Docket No. 50-382

SUBJECT: CORRECTIONS TO AMENDMENT NOS. 25 AND 32 TO FACILITY
OPERATING LICENSE NO. NPF-38

On November 20, 1987 and March 21, 1988, the Commission issued Amendment Nos. 25 and 32 respectively to Facility Operating License No. NPF-38 for the Waterford Steam Electric Station, Unit 3. Amendment No. 25 changed License Condition 2.C.14 to revise the approved fuel assembly locations in the fuel handling building during operational Modes 1-5 and allow fuel inspection/reconstitution outside an approved storage rack provided the inspection/reconstitution area was adequately borated. Amendment No. 32 changed the Technical Specifications (TS) by revising the time limits for monitoring linear heat rate and departure from nucleate boiling ratio using the core protection calculators when the core operating limit supervisory system is inoperable.

FIGURE 3.2-1
ALLOWABLE PEAK LINEAR HEAT RATE VS Tc

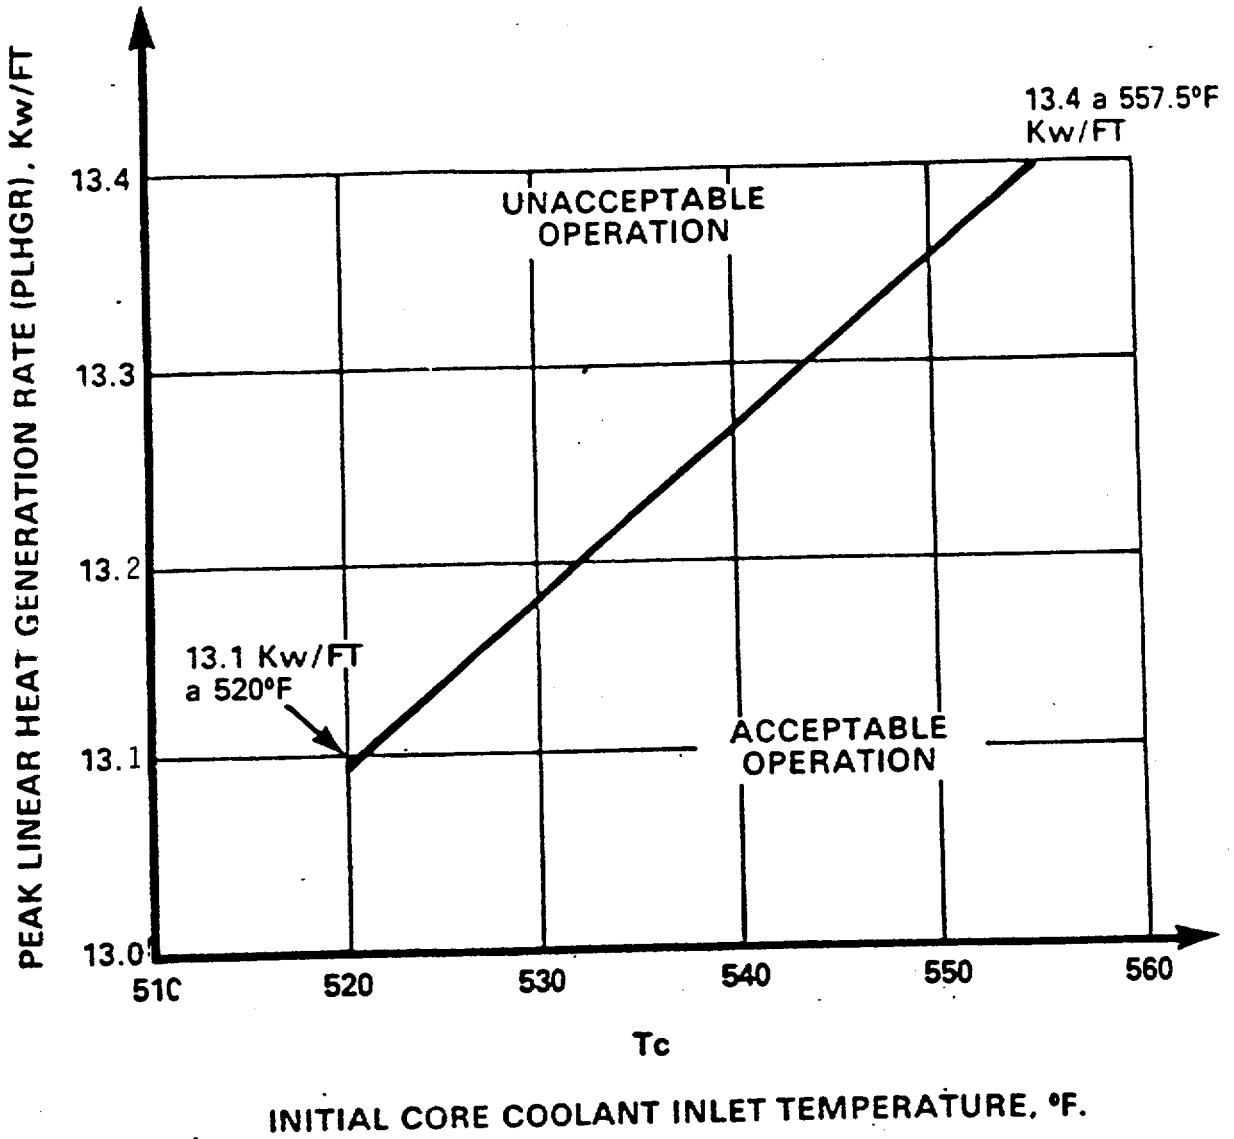
TS page 3/4 2-2 was issued as a backup page to Amendment No. 32 and contained no changes. It has been brought to our attention that the figure contains an error that was made when Amendment No. 12 was issued. Two values on the vertical axis are reversed. The correct TS page is enclosed.
